D. BAY

ECG – Concept Design Review Report

01 BC- BEACH CABIN (40 sq.m)

D.Bay
01 BC - Beach Cabin
40 m2

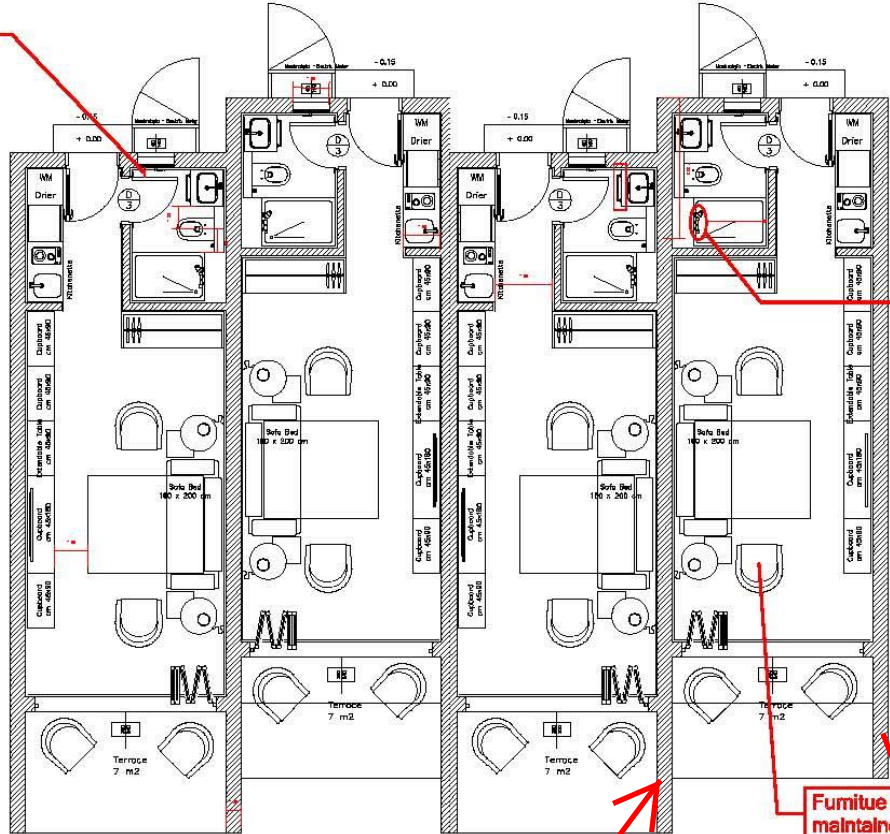
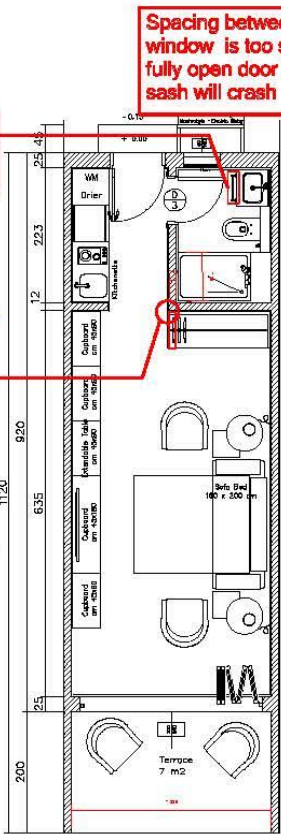
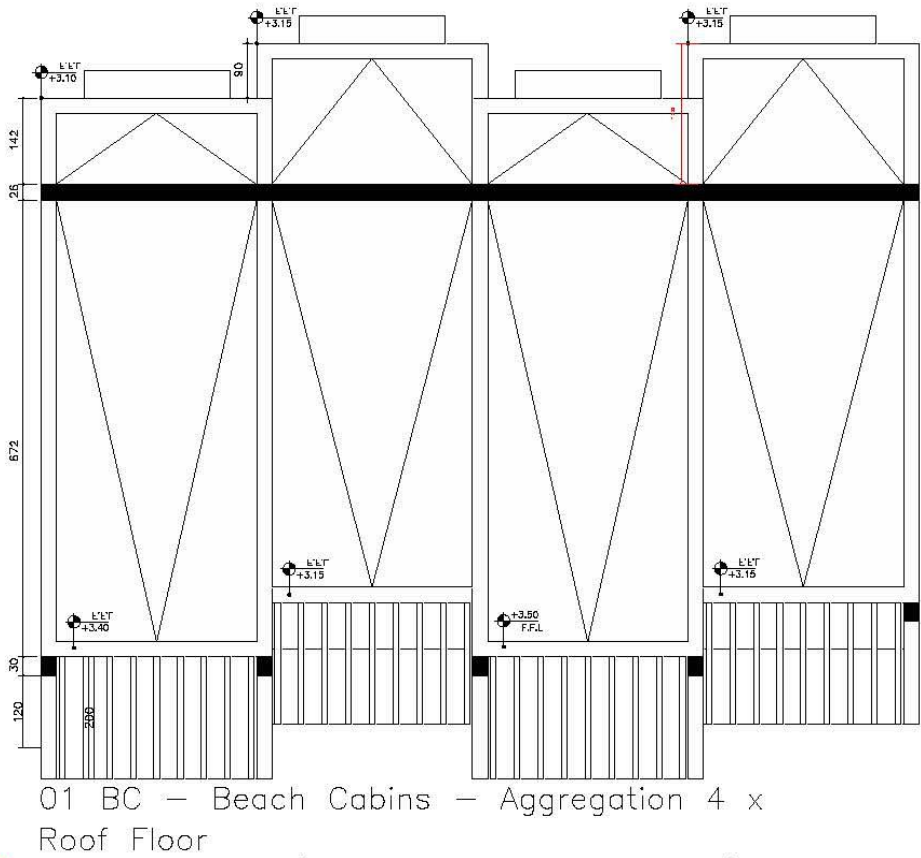
Spacing between door & window is too small, when fully open door leaf & window sash will crash

Towel rail location is impractical / non-functional

- Relation between wardrobe & wall is critical, unless materials are carefully selected & accurately implemented flush
- Built-in wardrobe sides would contribute cost reduction, as volume of wood component is lesser & ensures continuation of the wall finish
- This's applicable in case of fully furnished units marketing

- If shower head is relocated at the opposite side, there'll be potential for built in seat or shelves to replace
- At the same time, this will facilitate manual test of water temp. prior to getting into shower tray

- Furniture layout needs to be revisited to enhance functionality, e.g. in case sofa bed is maintained at sleeping mode,
- > How to provide nice seating arrangement near window
- > How to use extendable table comfortably & without interrupting circulation

No big issue. However, to be coordinated with ID consultant

ID consultant to further check

All residential units are fully finished scope only with no furniture. Please keep as it is with no wall nib

All intermediate terraces' separation walls to be same as shown in the marketing movie

Ok, please proceed

Please to be coordinated with ID consultant
